ADDENDUM No. 3

**ORG #207 – San Jacinto Elementary School - Renovation
ORG #273 – Pleasant Grove Elementary School – Renovation**

DALLAS INDEPENDENT SCHOOL DISTRICT

11/01/2024

OVERALL DEMOLITION PLAN

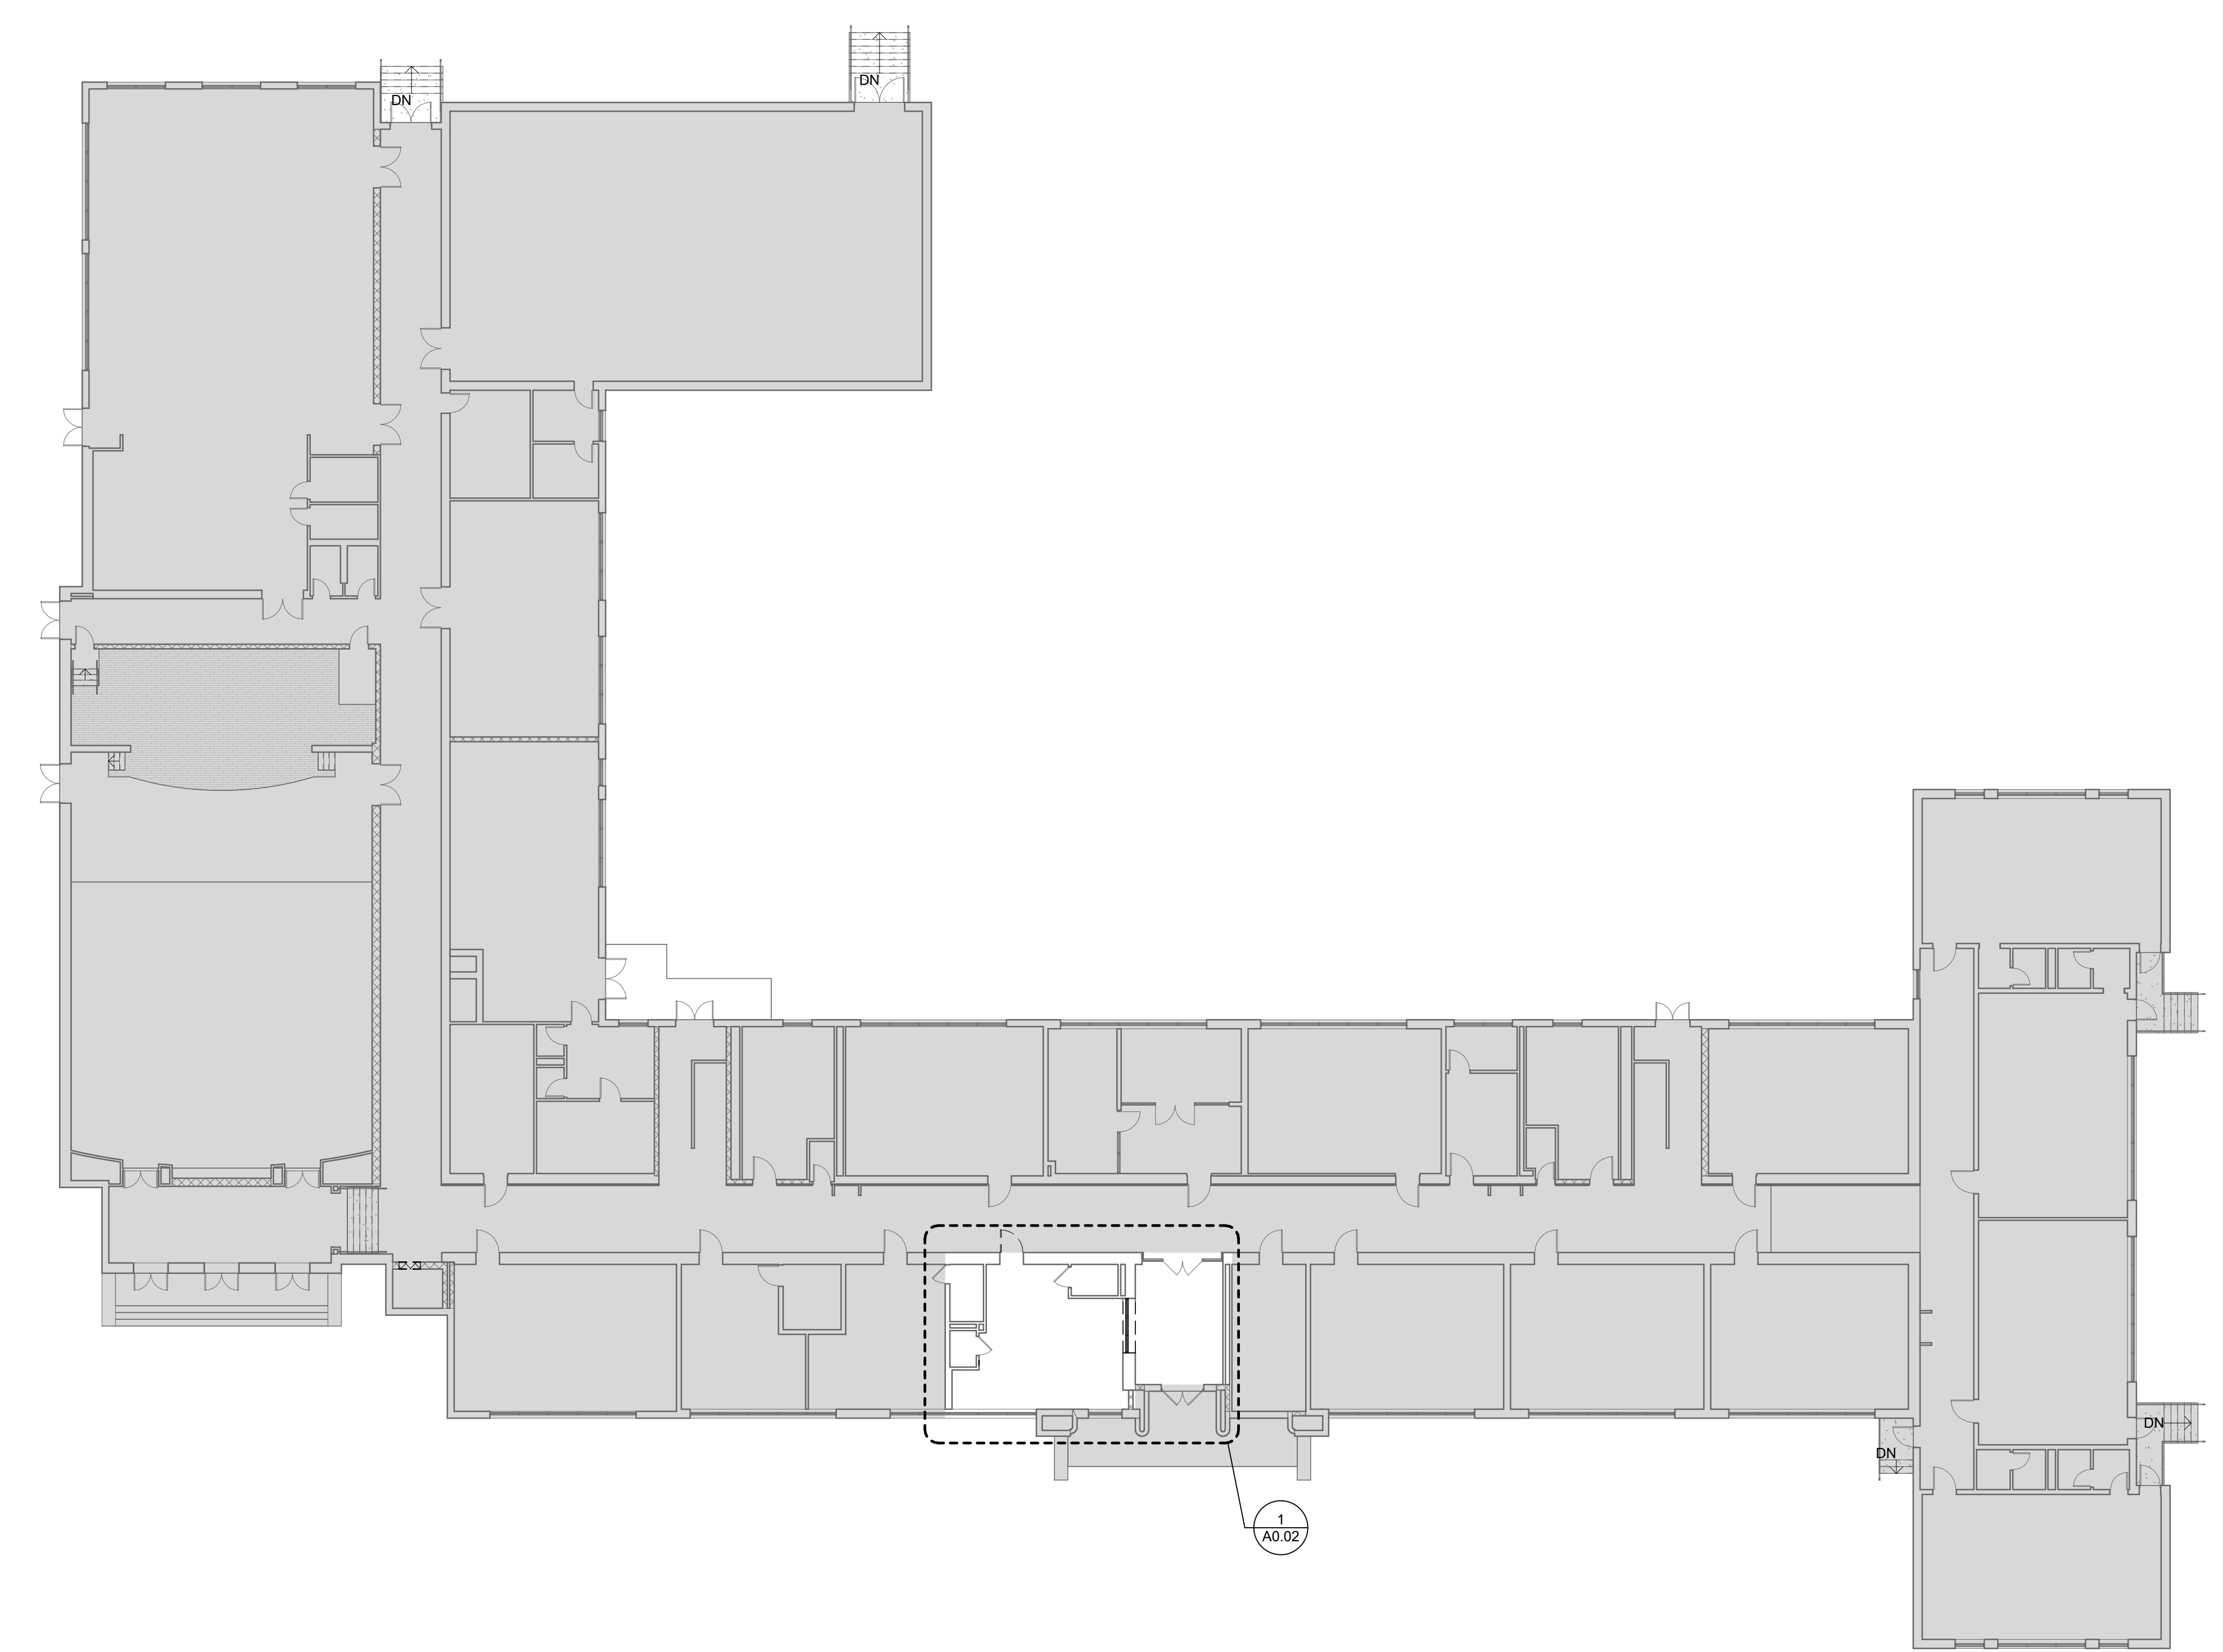
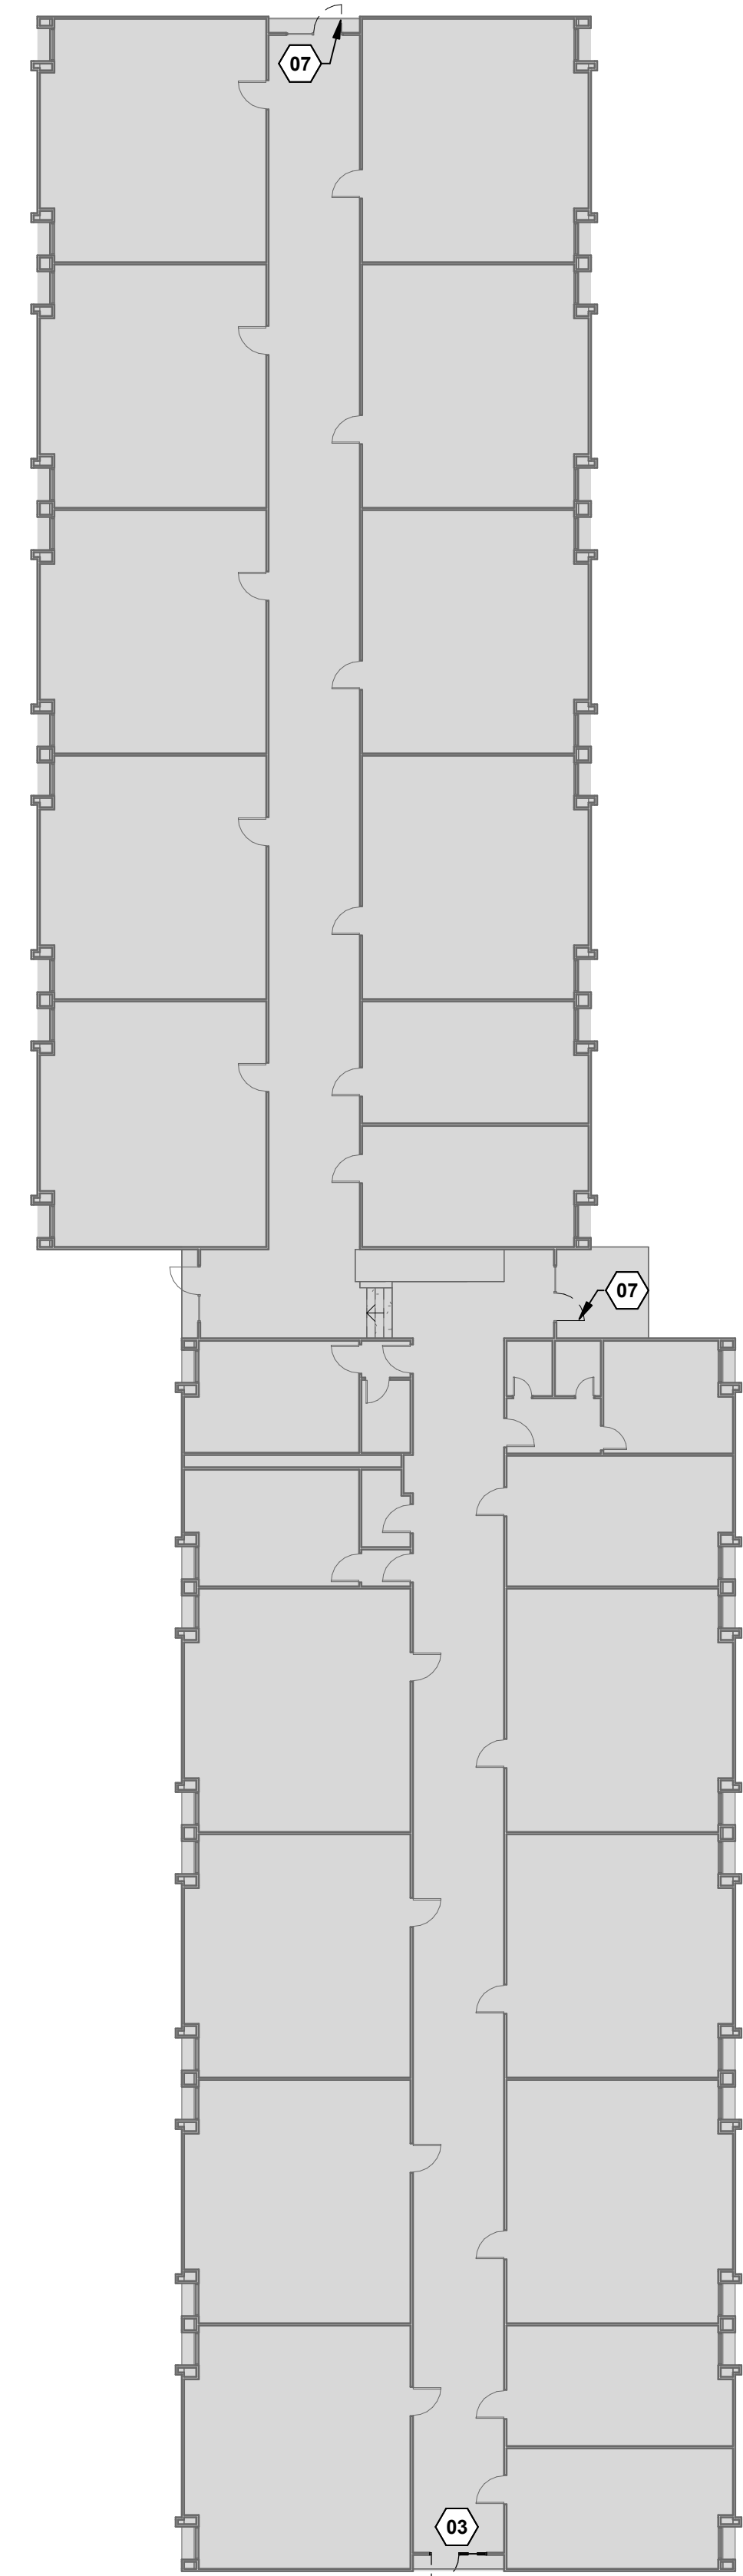
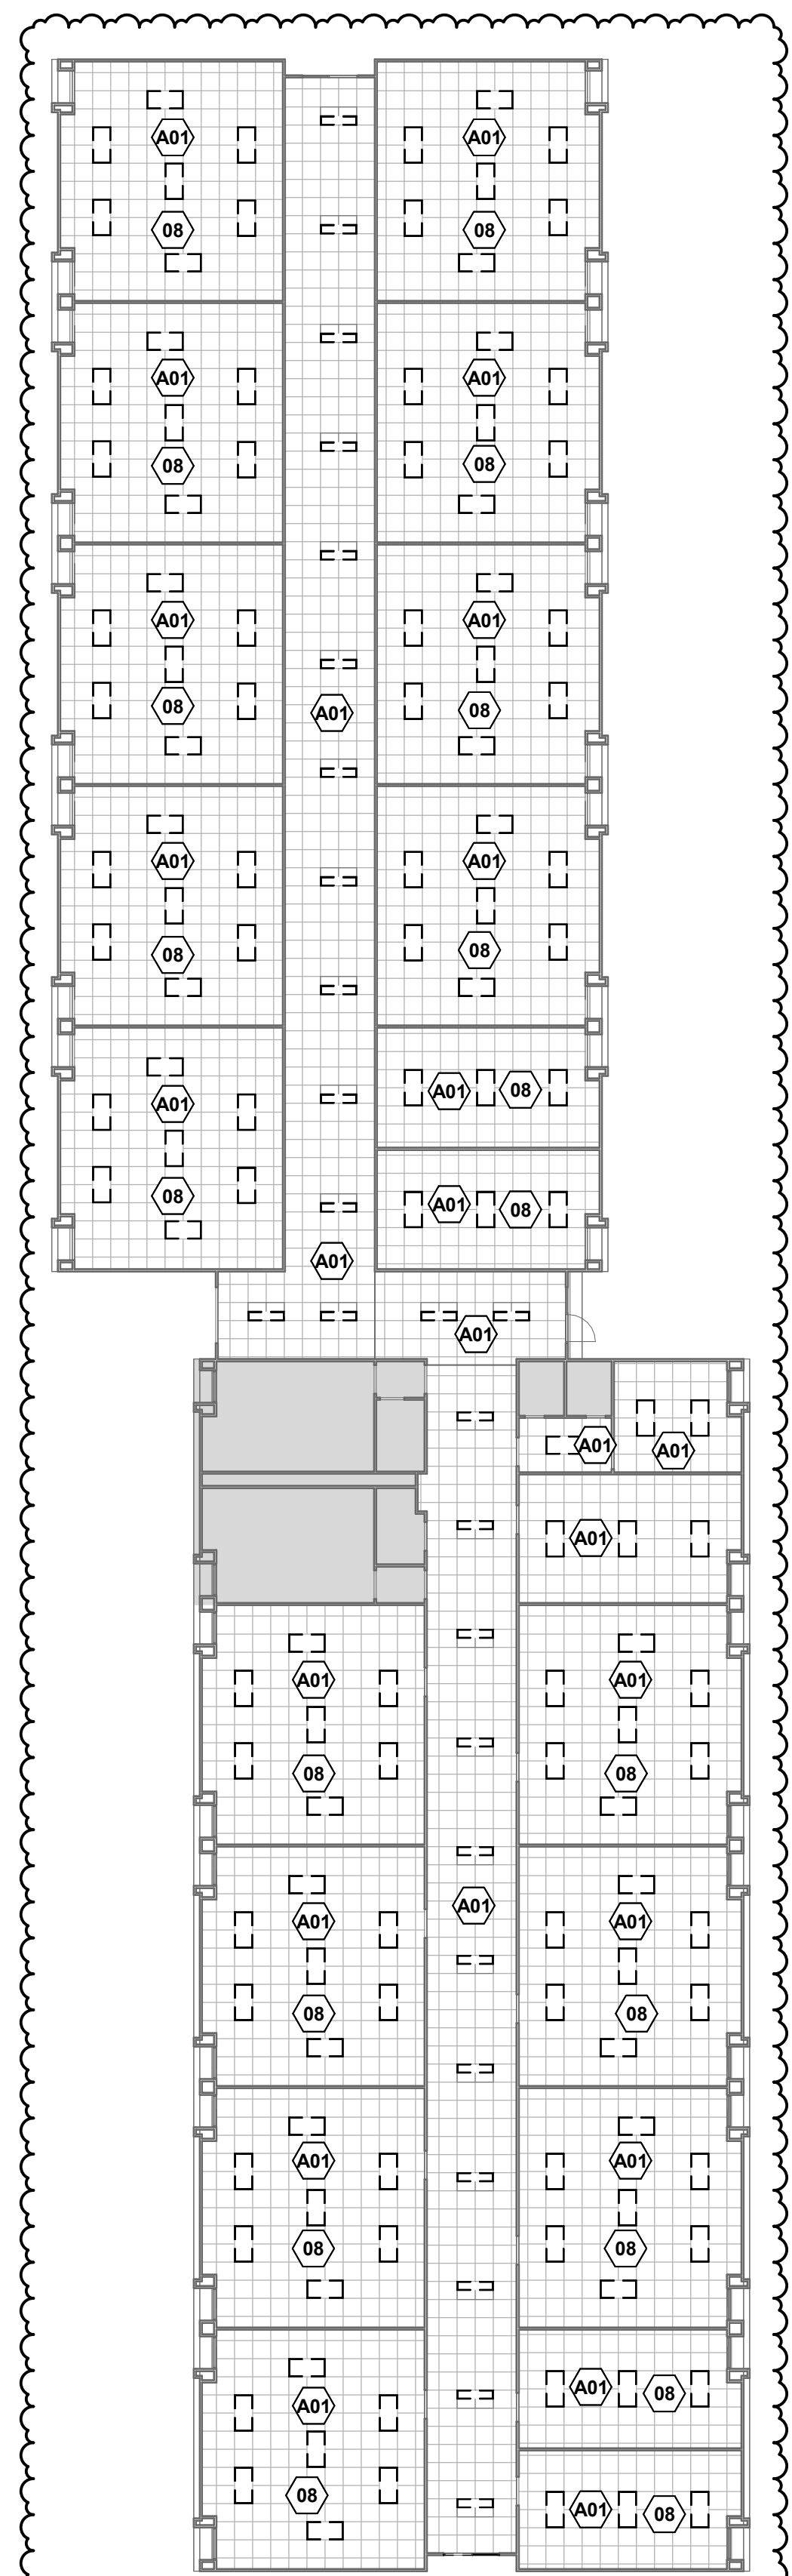
- Note added: “Removal / reinstallation of existing WAPs must be coordinated with DISD IT at least 2 weeks in advance.”
- Replace sheet with the revised attached A1.01.

- 01 REMOVE AND DISCARD PORTION OF EXISTING WALL AND PASS THRU WINDOW. PREP OPENING TO RECEIVE NEW STOREFRONT. PATCH AS NEEDED.
- 02 REMOVE MILLWORK AND SAVE FOR RELOCATION
- 03 DOOR, HARDWARE AND FRAME TO BE REMOVED PREP FOR A NEW DOOR WITH ELECTRIFIED HARDWARE
- 04 REMOVE MILLWORK AND SAVE FOR POSSIBLE RELOCATION COORDINATE WITH OWNER
- 05 REMOVE THERMOSTAT AND CHECK-IN DEVICE SAVE FOR RELOCATION, REF. MEP
- 06 EXISTING MILLWORK TO REMAIN. PROTECT DURING CONSTRUCTION.
- 07 DOOR TO BE REMOVED PREP FOR A NEW DOOR WITH ELECTRIFIED HARDWARE FRAME AND RELOCATION TO REMAIN.
- 08 REMOVAL / REINSTALLATION OF EXISTING WAPS MUST BE COORDINATED WITH DISD AT LEAST 2 WEEKS IN ADVANCE.
